Discussion on increasing the Schnupp asymmetry

A preliminary document exploring allowable ETM's & ITM's mechanical clearances along the beam center line & the feasibility of cookie cutter 'BLANKS' for the following chambers:

BSC3-L1 (ITMX)

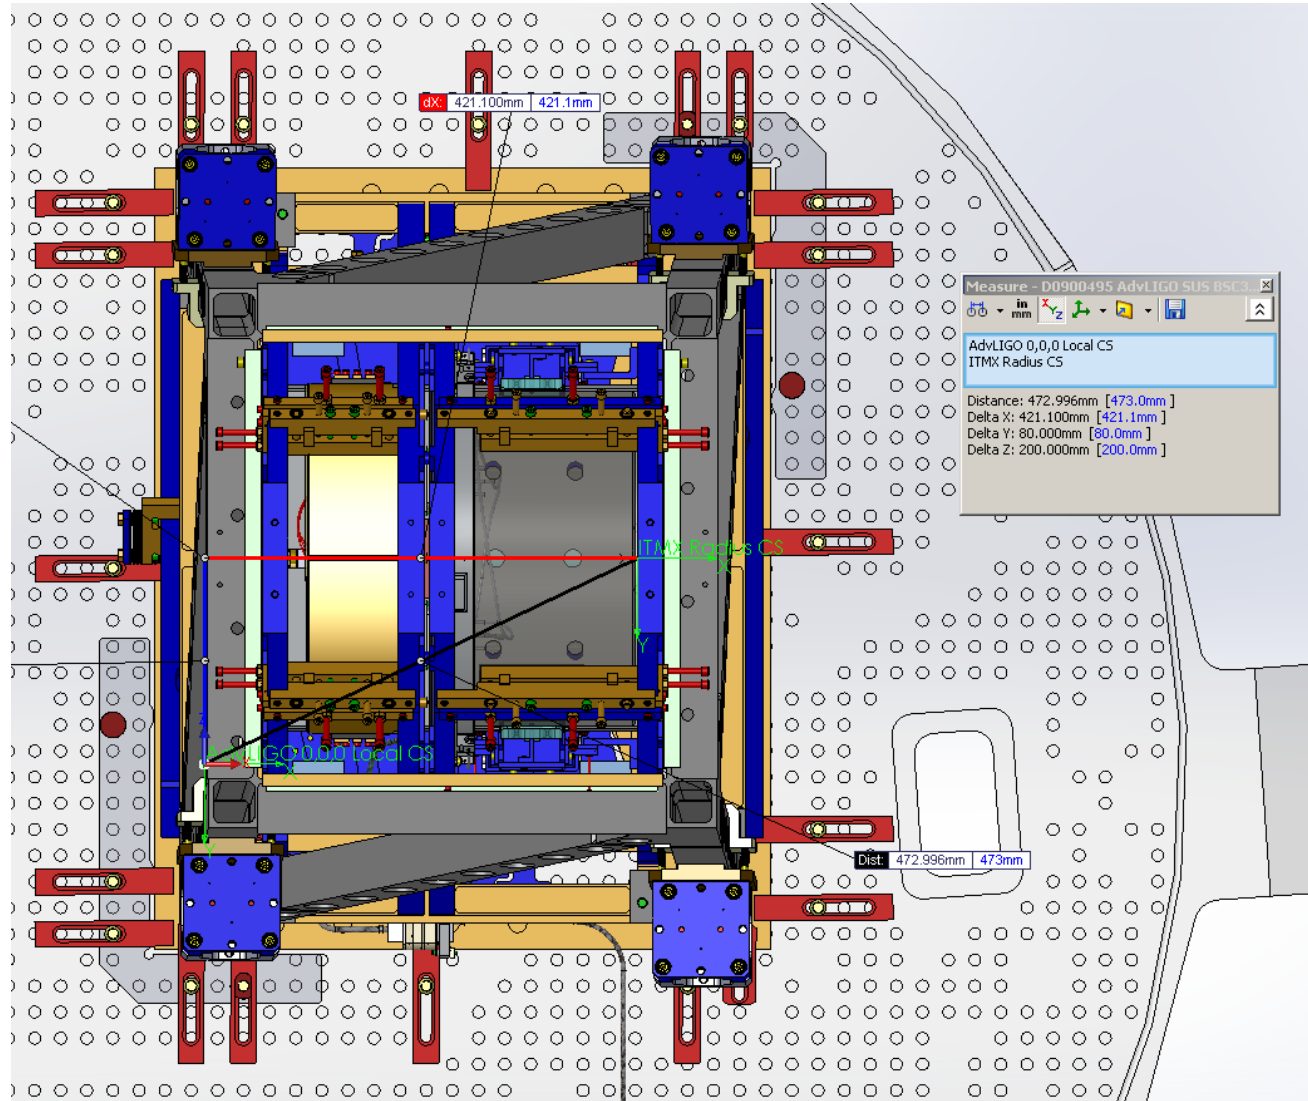
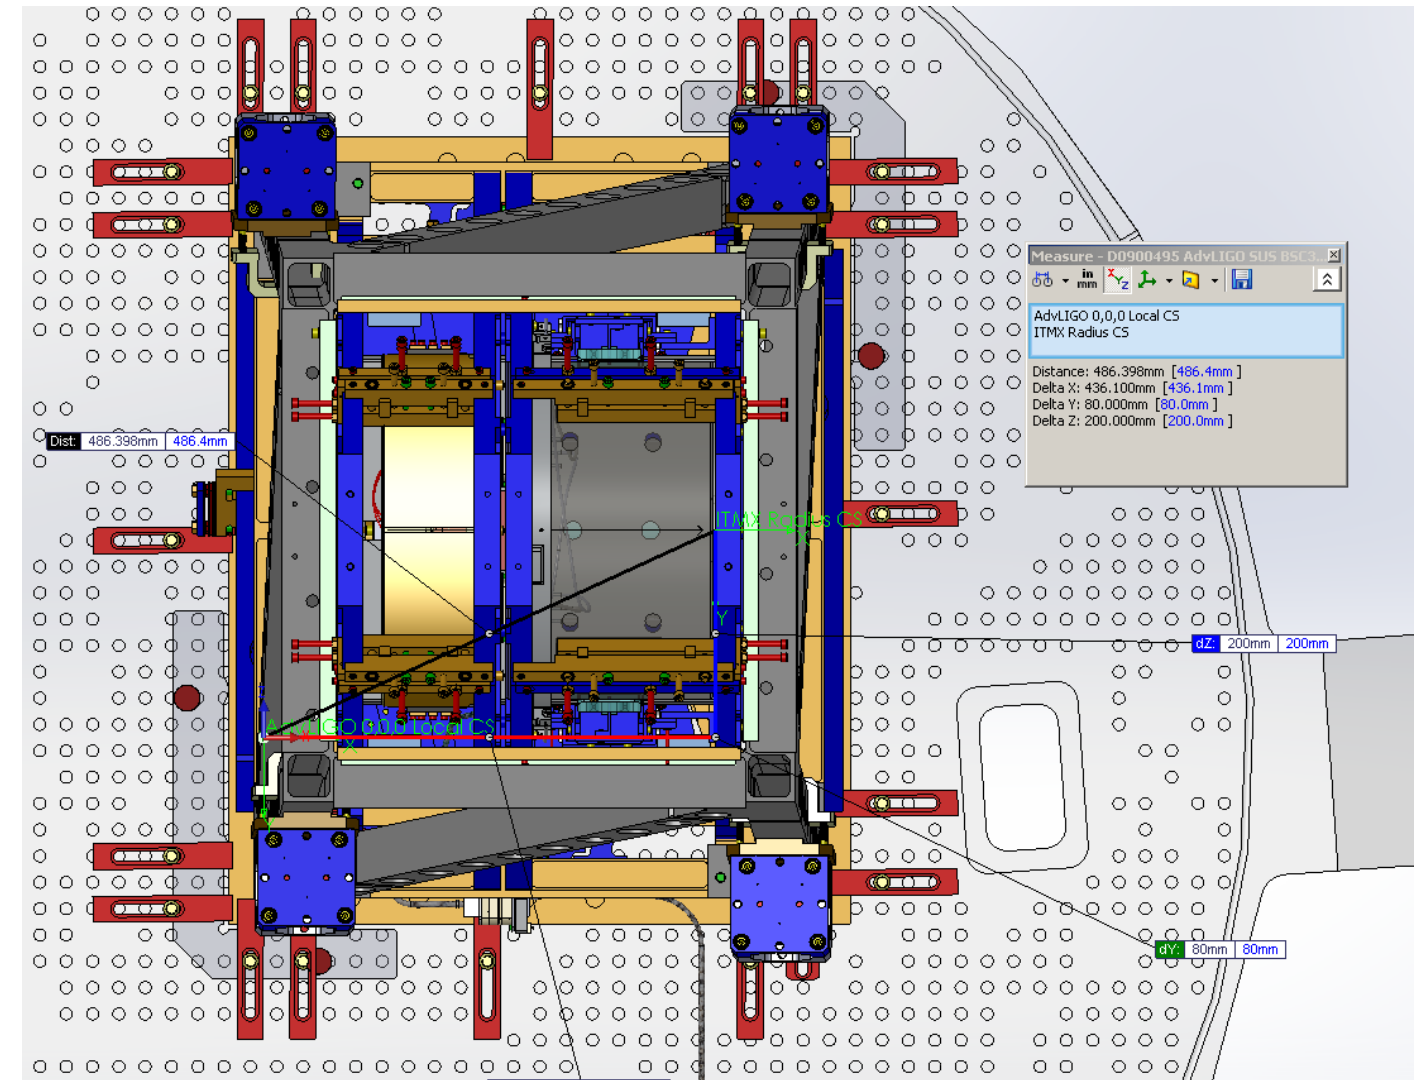
BSC3-L1 (ITMX) CURRENT:

Distance: 472.996mm [473.0mm]
Delta X: 421.100mm [421.1mm]
Delta Y: 80.000mm [80.0mm]
Delta Z: 200.000mm [200.0mm]

15mm AWAY FROM GLOBAL 0

Distance: 486.398mm [486.4mm]
Delta X: 436.100mm [436.1mm]
Delta Y: 80.000mm [80.0mm]
Delta Z: 200.000mm [200.0mm]

BSC1-L1 (ITMY) CURRENT:

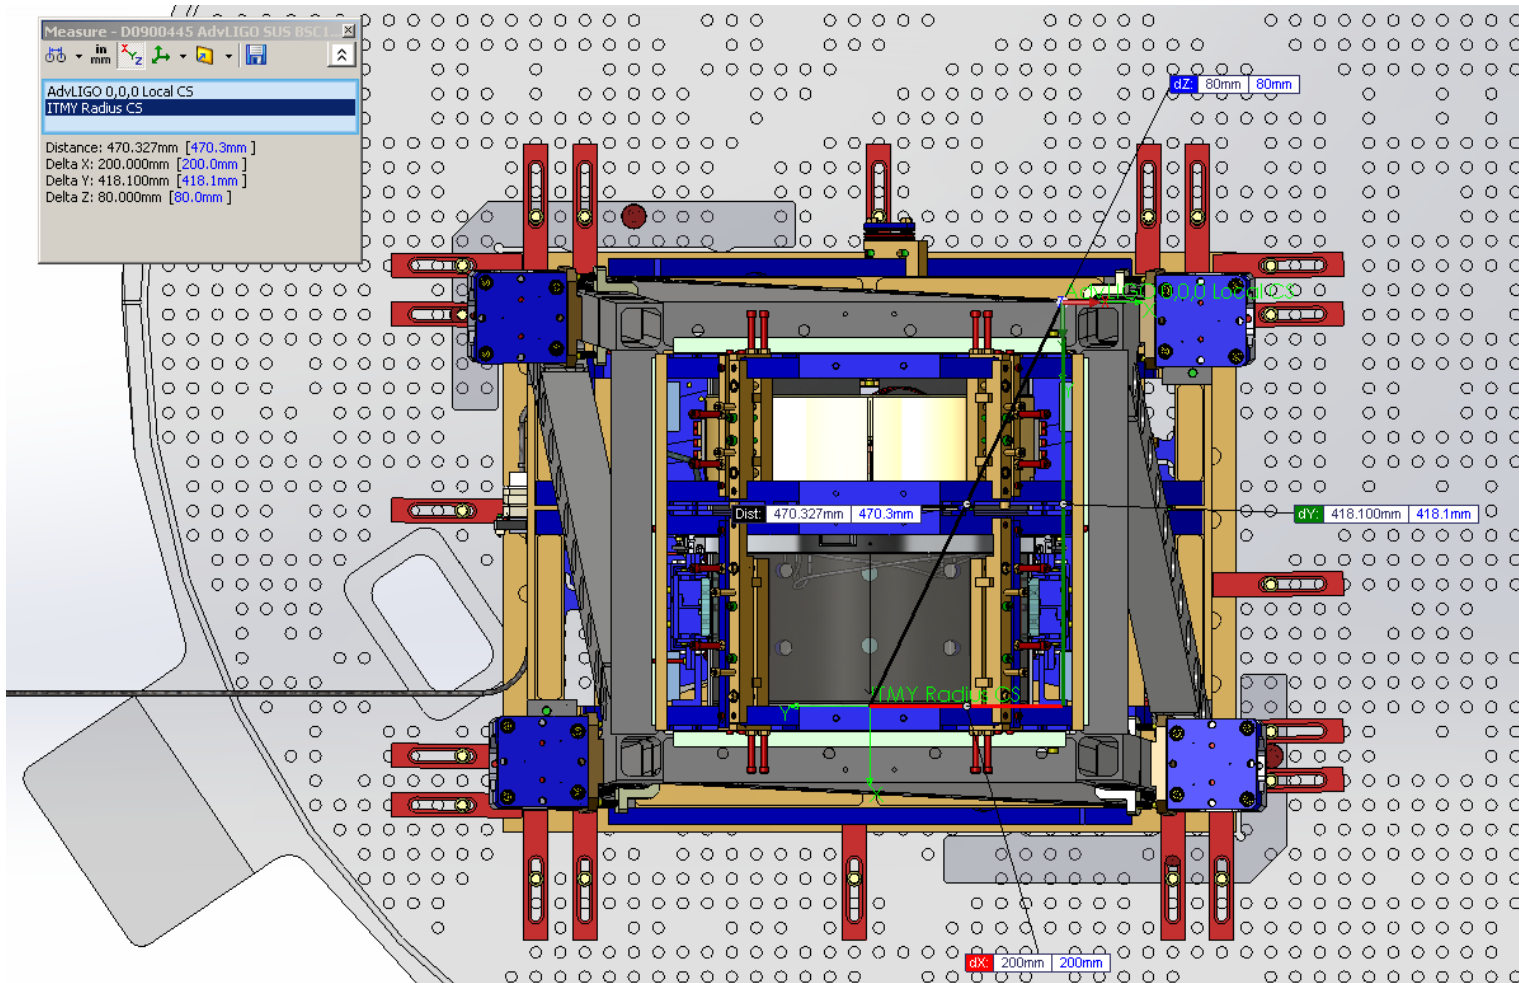
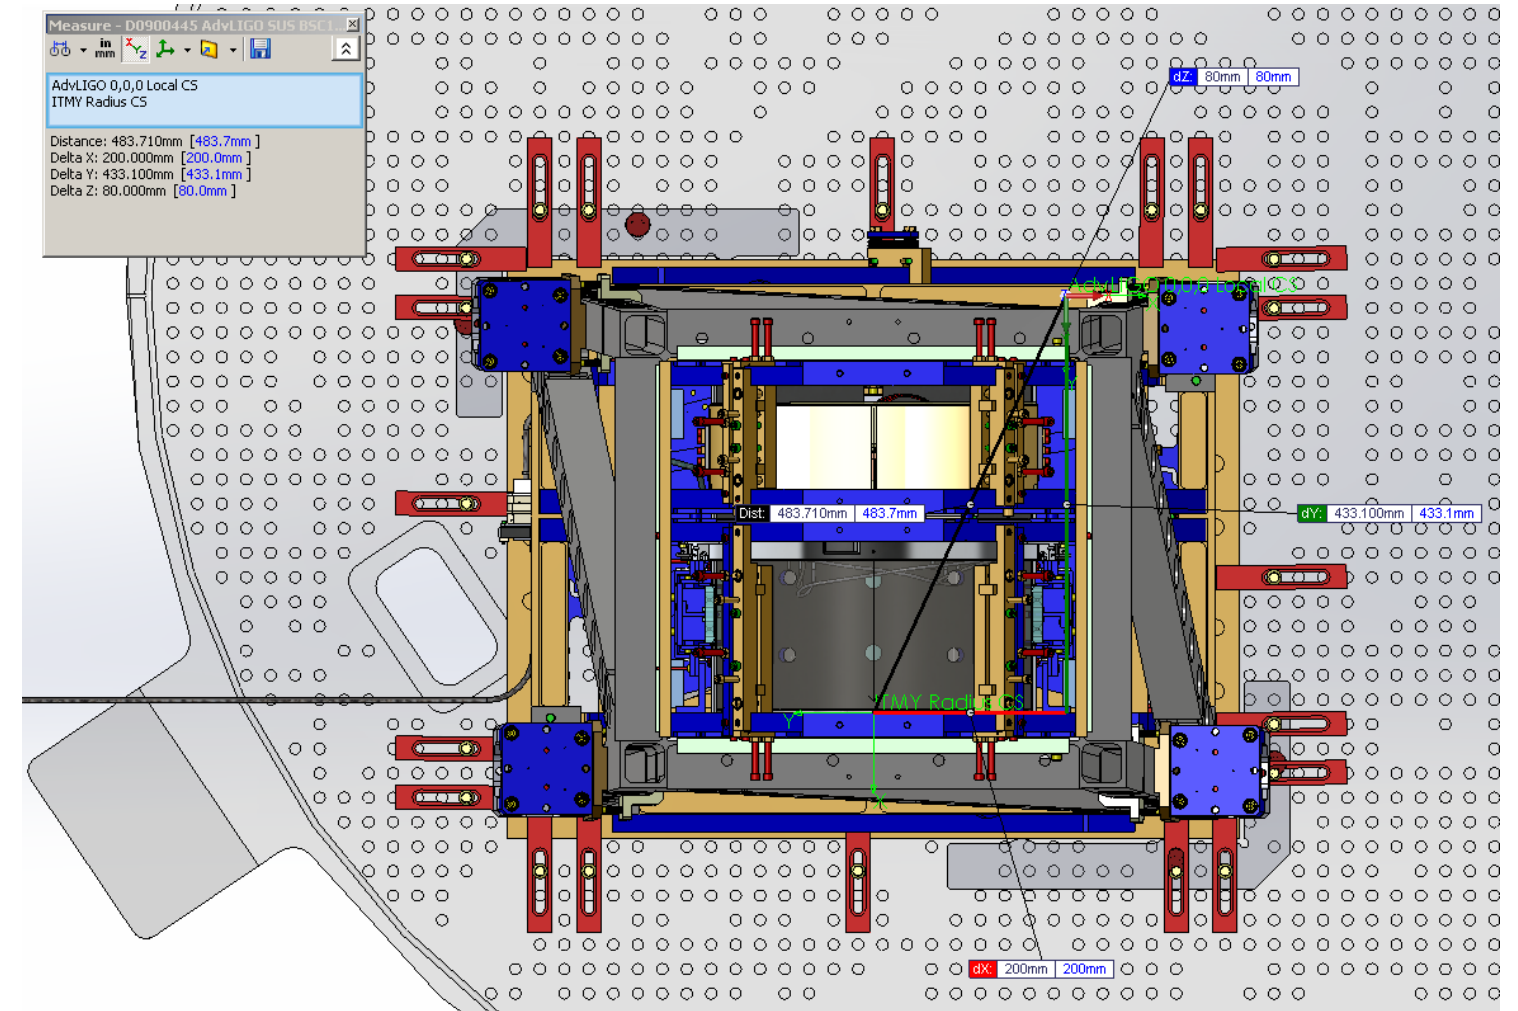
Distance: 470.327mm [470.3mm]
Delta X: 200.000mm [200.0mm]
Delta Y: 418.100mm [418.1mm]
Delta Z: 80.000mm [80.0mm]

BSC1-L1 (ITMY) Schnupp Effect: 15mm Toward GLOBAL 0

Distance: 483.710mm [483.7mm]
Delta X: 200.000mm [200.0mm]
Delta Y: 433.100mm [433.1mm]
Delta Z: 80.000mm [80.0mm]

BSC5-L1 (ETMY) CURRENT:

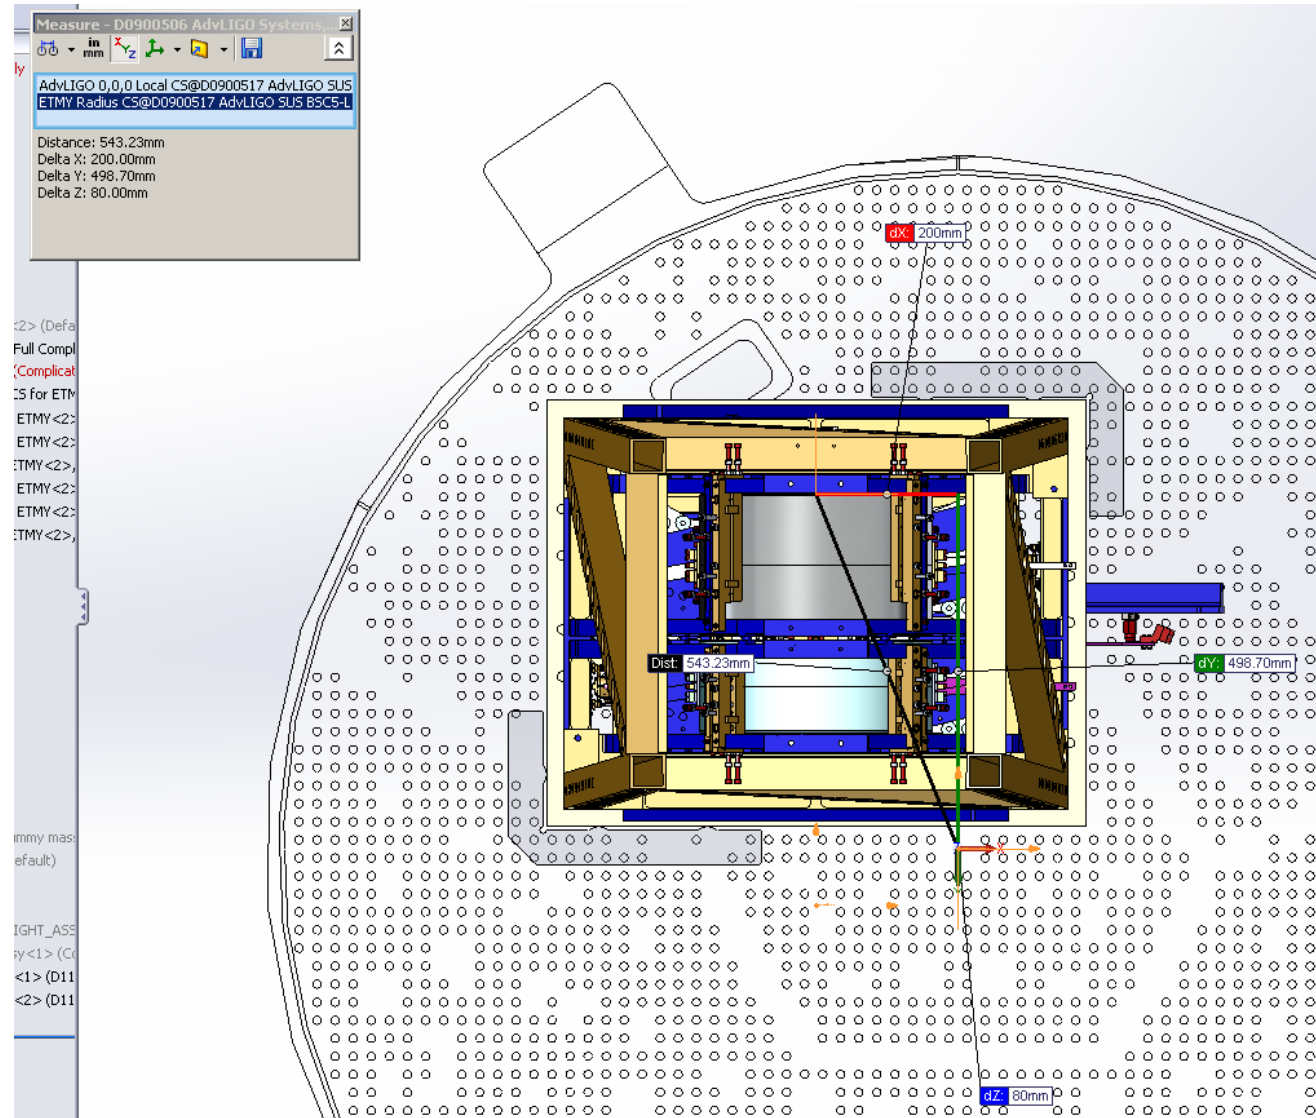
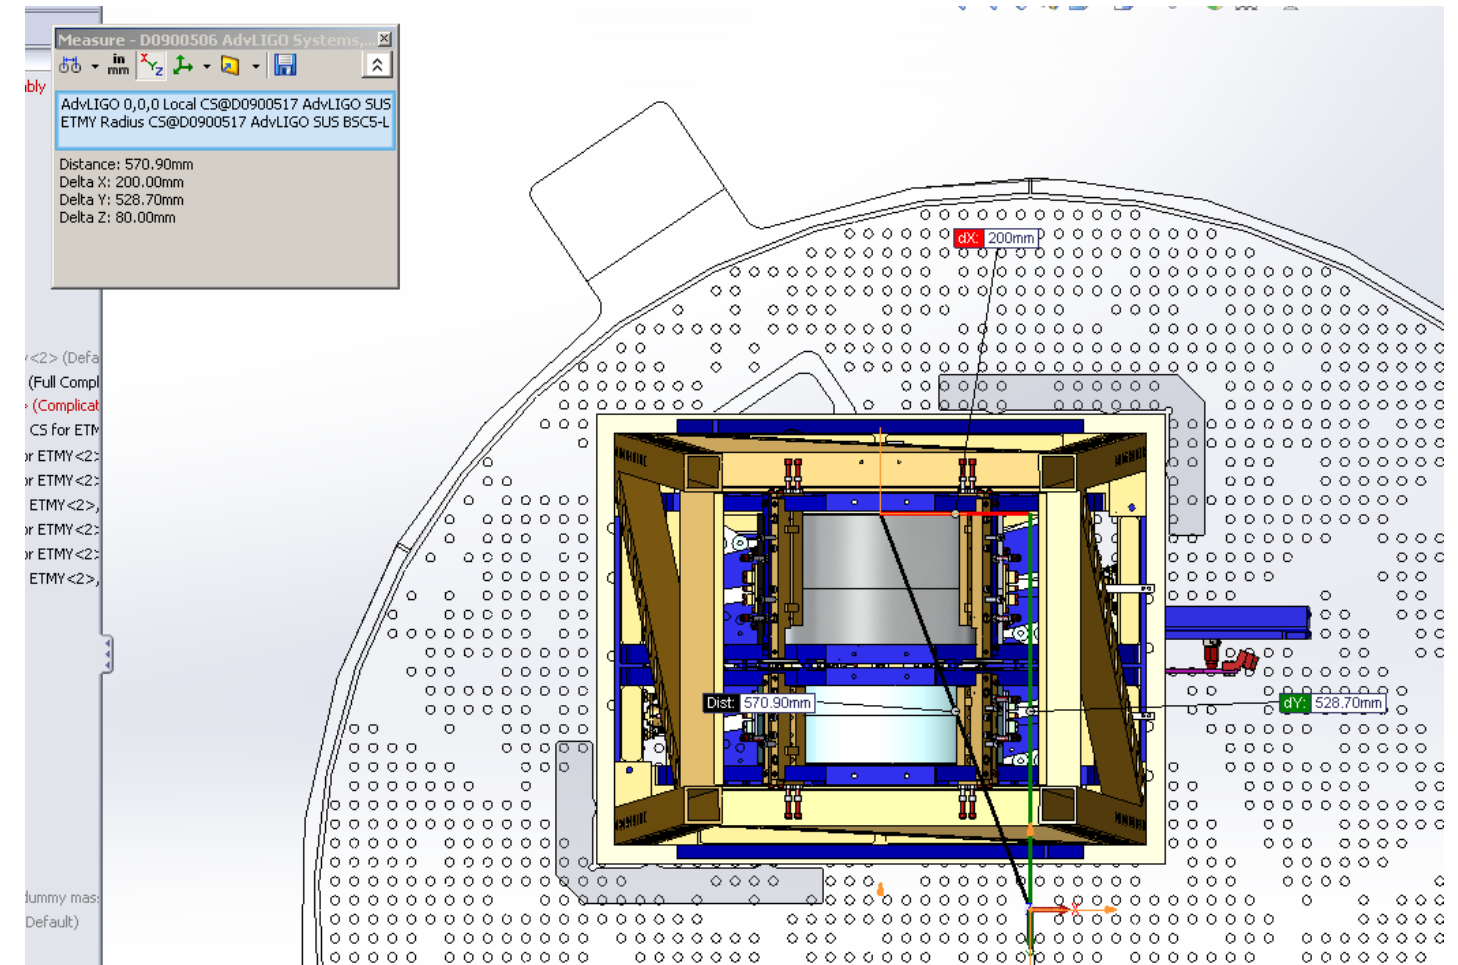
Distance: 543.23mm
Delta X: 200.00mm
Delta Y: 498.70mm
Delta Z: 80.00mm

BSC5-L1 (ETMY) Schnupp Effect: 30mm Toward GLOBAL 0

Distance: 570.90mm
Delta X: 200.00mm
Delta Y: 528.70mm
Delta Z: 80.00mm
